Site Accessibility Evaluation

Bear Creek Regional Park

Accessibility Evaluation

***Inspection Date: 07/08/2019
Inspector: David Mejia***

Finding: 1

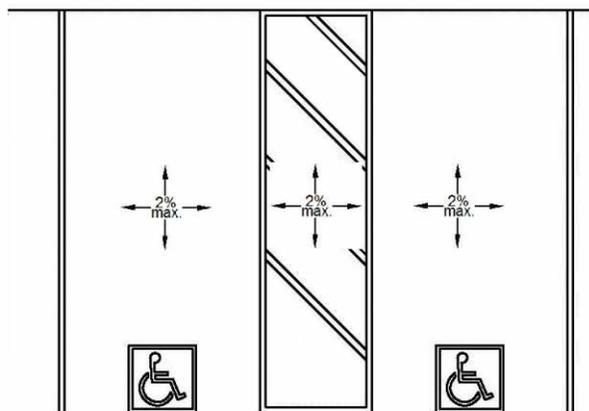
The running slope (long dimension) of the accessible parking stall exceeds 2%.

Running slope at
4.37%

The running slope for the 5 accessible parking stalls exceeds the 2% maximum. Re-pavement and re-striping will be required to meet compliance.

Finding: 2

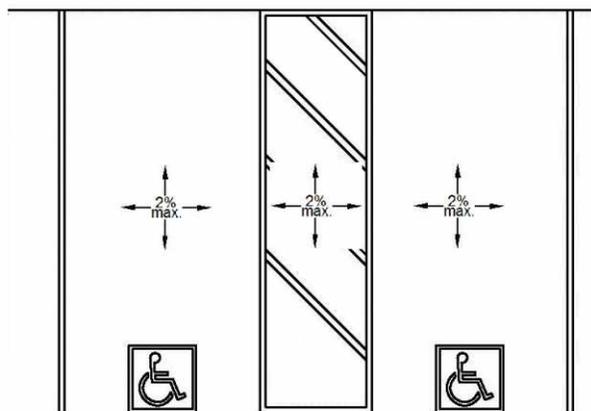
The running slope of the access aisle (long dimension) exceeds 2%.

Running slope at 5.5 %

The running slope for all access aisles exceeds the 2% maximum. Re-pavement and re-stripping will be required to meet compliance.

Finding: 3

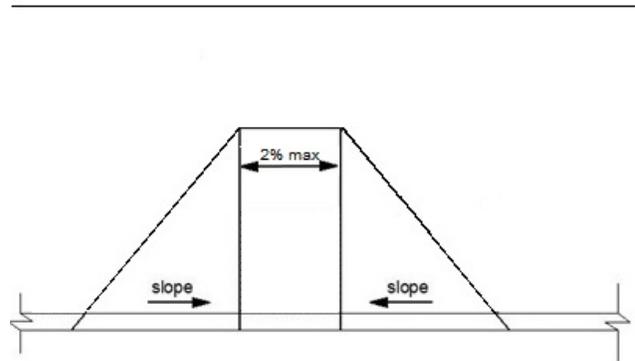
The curb ramp on the accessible route contains cross slopes greater than 2%.

Bottom landing cross slope at 6.55%

Replace with new parallel curb ramp meeting the 2% cross and running slope at the bottom landing and not to exceed 8.33% on the side ramps.

Finding: 5

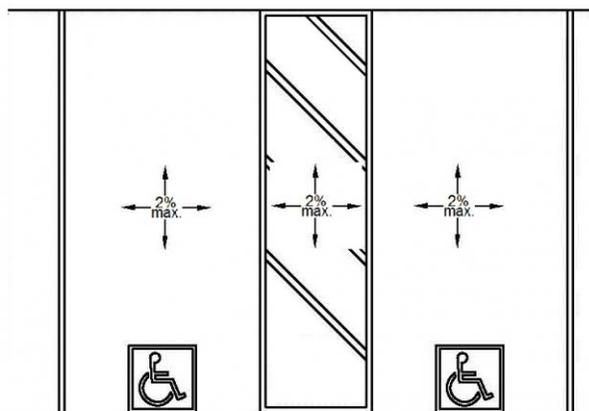
The cross slopes (narrow dimension) and/or running slopes (long dimension) of the accessible stall exceeds 2%.

6.20% running slope /
2.44% cross slope

May not be able to provide 100% compliant accessible parking stalls and access aisles on Creek Crossing Street on the west side of the park due to elevation and hilly terrain. Recommend providing more accessible parking stalls and accessible aisles on the south and north parking lots. Also, identified accessible parking stalls and access isles on Creek Crossing Street should be located on the flattest possible section if possible.

Finding: 6

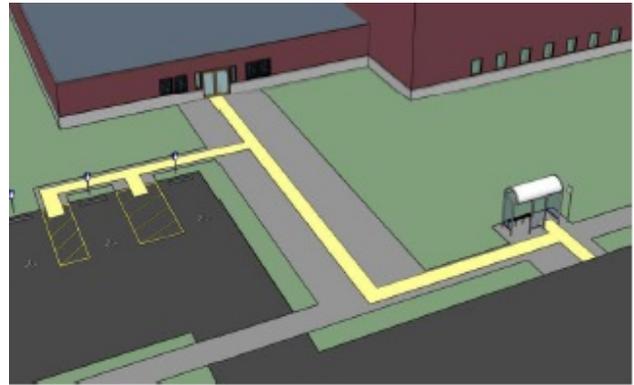
The accessible parking is not located on the shortest accessible route to the parking facility entrance.

Accessible parking
stalls missing access
isle

N/A - Refer to Finding

Finding: 7

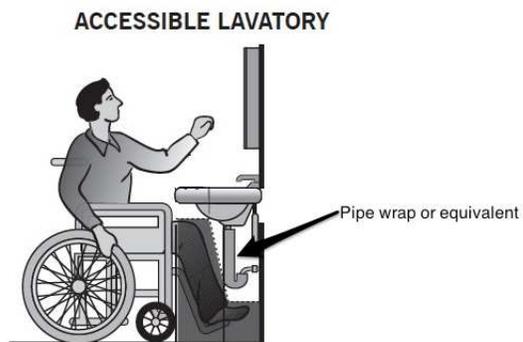
The water and drain pipes under the lavatory are not adequately insulated.

Drain pipes not insulated

Insulate drain pipes underneath lavatory.

Finding: 8

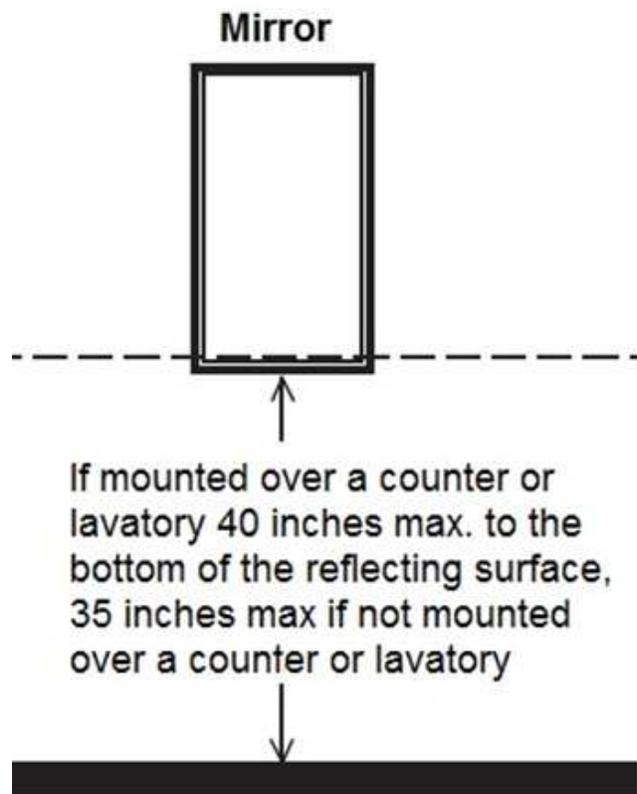
The mirror is mounted too high.

41.5 inches above
finished floor

Lower mirror to a maximum of 40 inches above finished floor measured to the bottom edge of the reflective surface. Recommend lowering mirror 2 inches.

Finding: 9

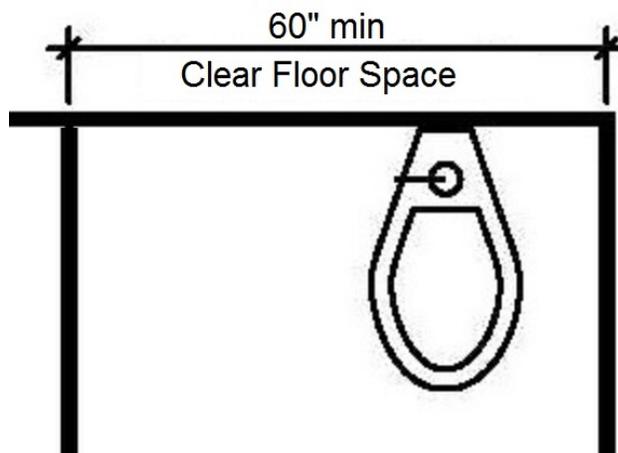
The toilet compartment is not wide enough.

41.5 inches in width

Providing the minimum required width clearance to the restroom is technically infeasible at this time because existing structural conditions would require removing or altering a load-bearing member that is an essential part of the structural frame; or because other existing physical or site constraints prohibit modification or addition of elements, spaces, or features that are in full and strict compliance with the minimum requirements. Best practice measures are recommended to ensure restroom is accessible to the maximum extent possible. Major remodel/reconstruction will be required to meet current ADA standards.

Finding: 10

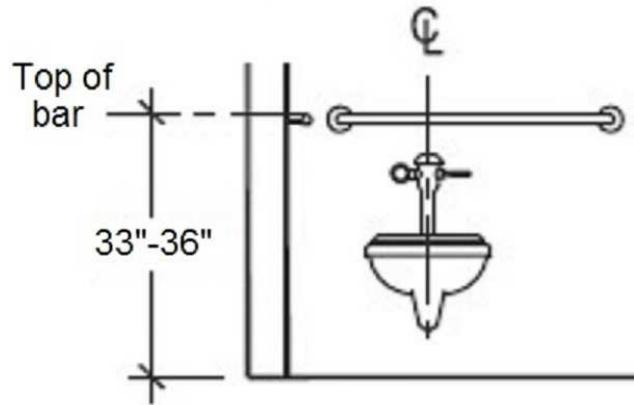
The rear grab bar is missing.

Missing rear grab bar

Install rear grab bar at 36 inches maximum above finished floor measured to the top of the gripping surface. Please see finding details for compliant measurements. Rear grab bar may not meet compliance clearances or length due to structural limitations.

Finding: 11

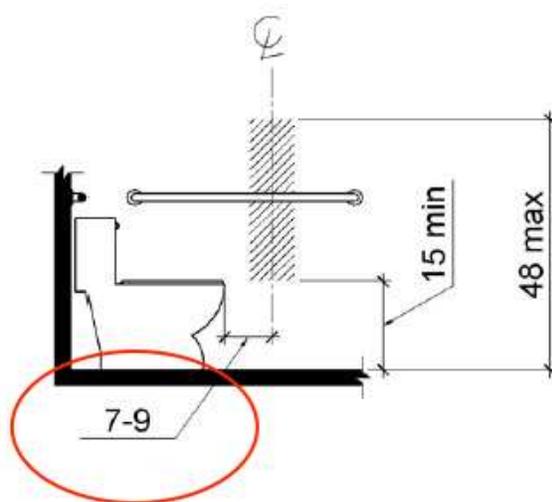
The toilet paper is not installed within the compliant range in front of the toilet.

17 inches from rear wall

Re-position toilet paper dispenser to be within 7 inches minimum to 9 inches maximum in front of the toilet measured to the centerline of the dispenser.

Finding: 12

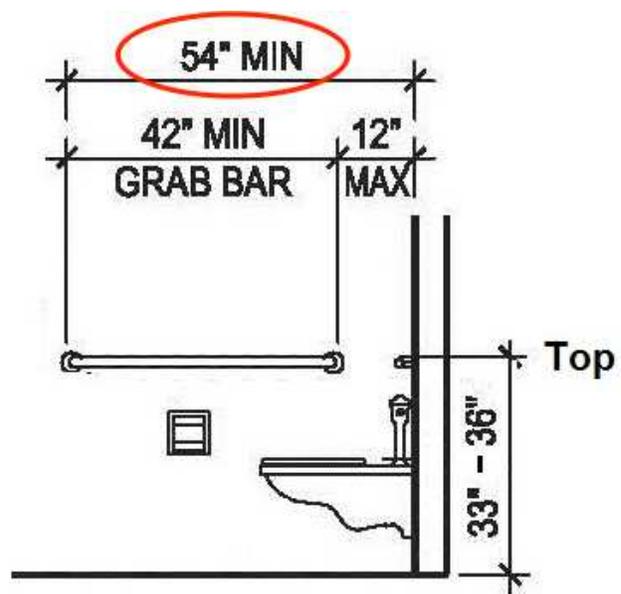
The side grab bar does not extend far enough from the rear wall.

52.5 inches from rear wall

Adjust side grab bar not to exceed 12 inches from rear wall. The side grab bar must be 42 inches minimum in length and extend at least 54 inches minimum beyond the rear wall.

Finding: 13

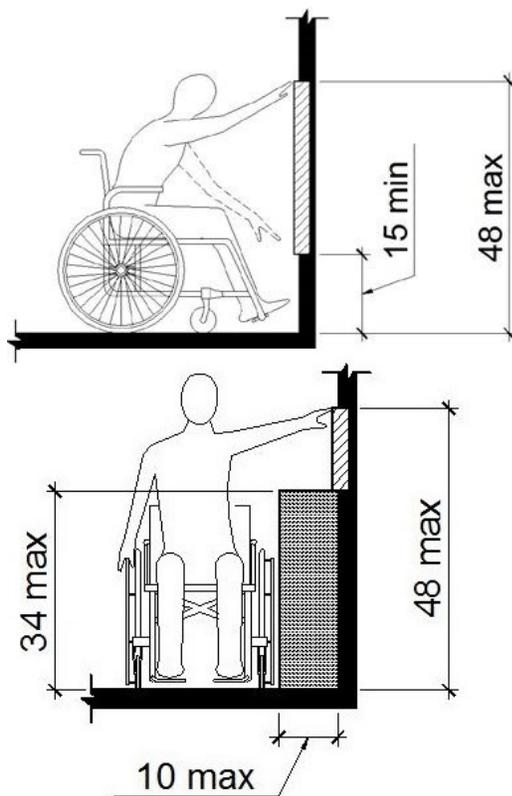
The coat hook is installed greater than 48 inches above the finished floor.

62.5 inches above
finished floor

Lower coat hook 14 inches minimum or install another coat hook not to exceed a maximum height of 48 inches above finished floor.

Finding: 14

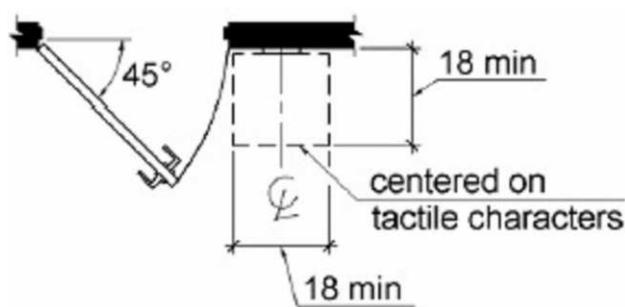
Clear floor space is not provide at the tactile door sign.

6 inches from latch side

Move to adjacent wall due to no wall space or can be placed directly on the door if door opens inward.

Finding: 15

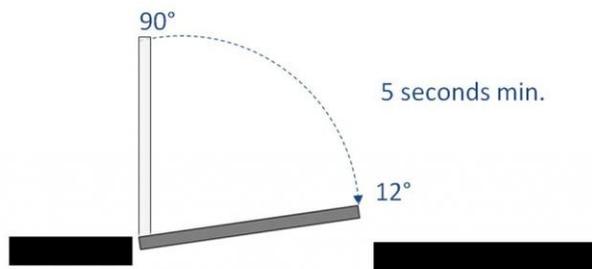
The door is equipped with a door closer and returns to a closed position too quickly.

3 seconds to closed position

Adjust door closer to allow a minimum of 5 seconds to move from the open position at 90 degrees to 12 degrees from the latch/locking mechanism.

Finding: 16

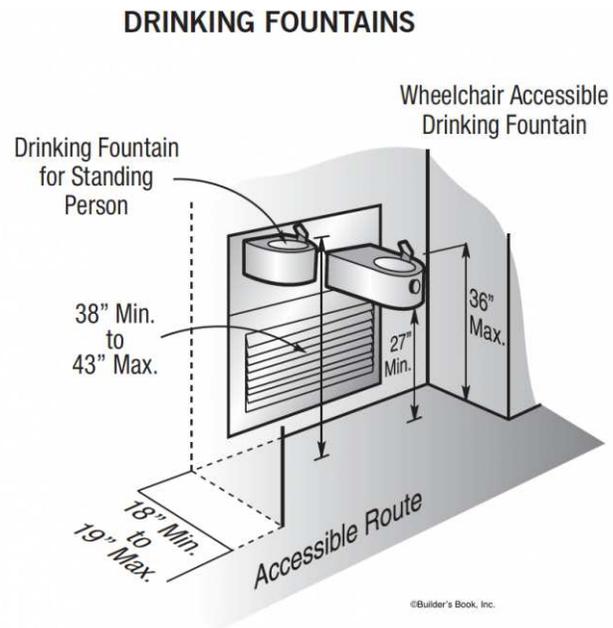
The drinking fountain is not accessible.

12 inches from rear wall

Replace existing drinking fountain due to multiple violations. Drinking fountains shall be positioned for a forward approach and a required clear floor space of 30" x 48" centered on the unit.

Finding: 17

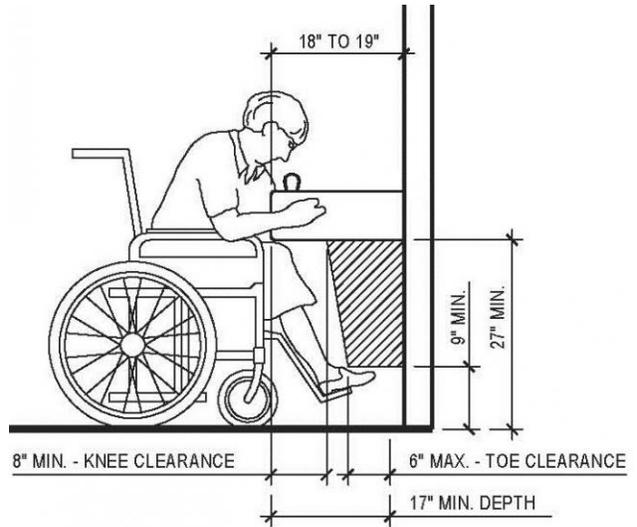
There is not enough knee clearance under the drinking fountain.

26.5 inches above
finished floor

Replace drinking fountain with one that provides a minimum height from the bottom edge of no less than 27 inches above finished floor and 8 inches minimum in depth for knee clearance.

Finding: 18

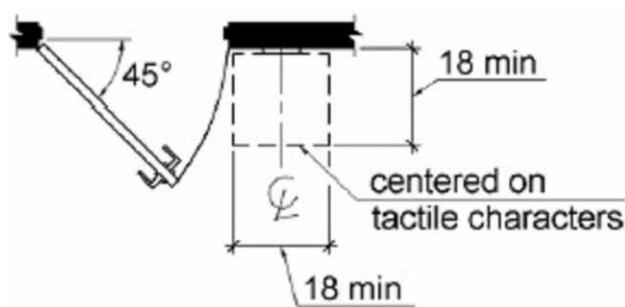
Clear floor space is not provide at the tactile door sign.

5.5 inches from latch side

Move to adjacent wall due to no wall space or can be placed directly on the door if door opens inward.

Finding: 19

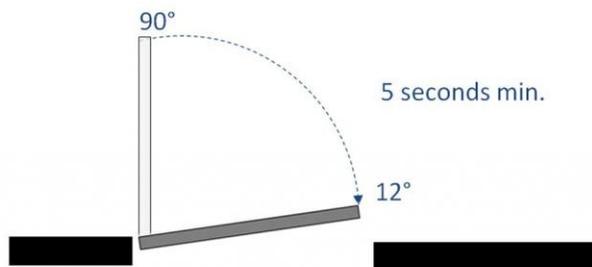
The door is equipped with a door closer and returns to a closed position too quickly.

2.5 seconds to closed position

Adjust door closer to allow a minimum of 5 seconds to move from the open position at 90 degrees to 12 degrees from the latch/locking mechanism.

Finding: 20

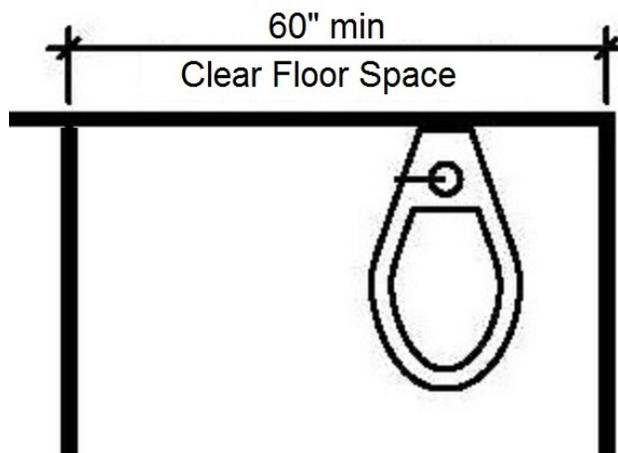
The toilet compartment is not wide enough.

42 inches in width

Providing the minimum required width clearance to the restroom is technically infeasible at this time because existing structural conditions would require removing or altering a load-bearing member that is an essential part of the structural frame; or because other existing physical or site constraints prohibit modification or addition of elements, spaces, or features that are in full and strict compliance with the minimum requirements. Best practice measures are recommended to ensure restroom is accessible to the maximum extent possible. Major remodel/reconstruction will be required to meet current ADA standards.

Finding: 21

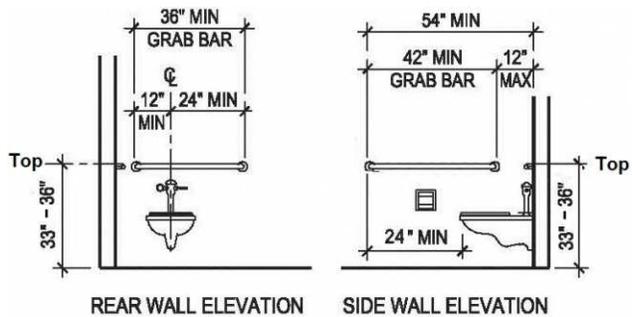
The rear grab bar is missing.

Rear grab bar missing

Install rear grab bar at 36 inches maximum above finished floor measured to the top of the gripping surface. Please see finding details for compliant measurements. Rear grab bar may not meet compliance clearances or length due to structural limitations.

Finding: 22

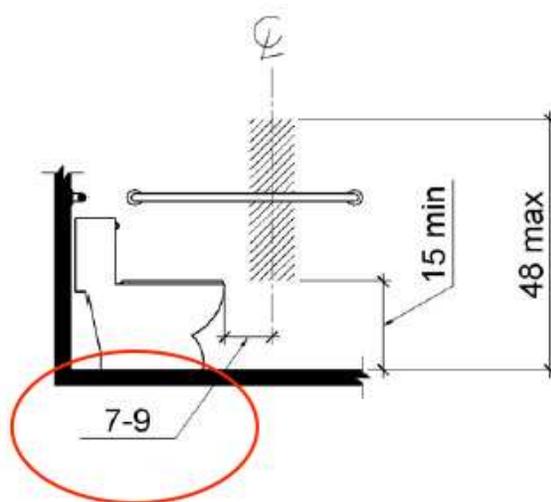
The toilet paper is not installed within the compliant range.

16 inches from rear wall

Re-position toilet paper dispenser to be within 7 inches minimum to 9 inches maximum in front of the toilet measured to the centerline of the dispenser.

Finding: 23

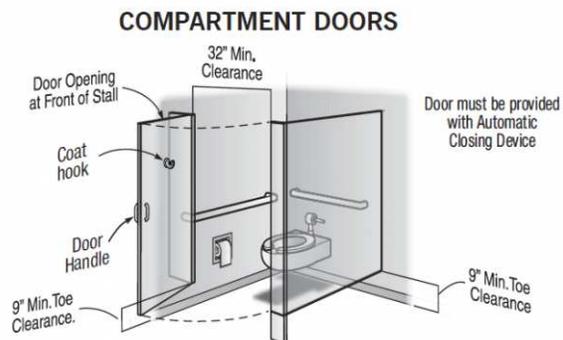
The compartment door is not self closing.

Does not self close

Adjust or install automatic closing hinges.

Finding: 24

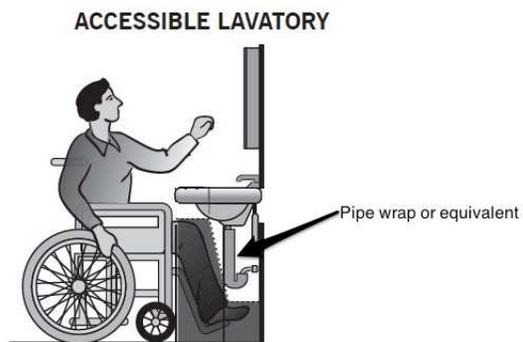
The water and drain pipes under the lavatory are not adequately insulated.

Drain pipes not insulated

Insulate drain pipes underneath lavatory.
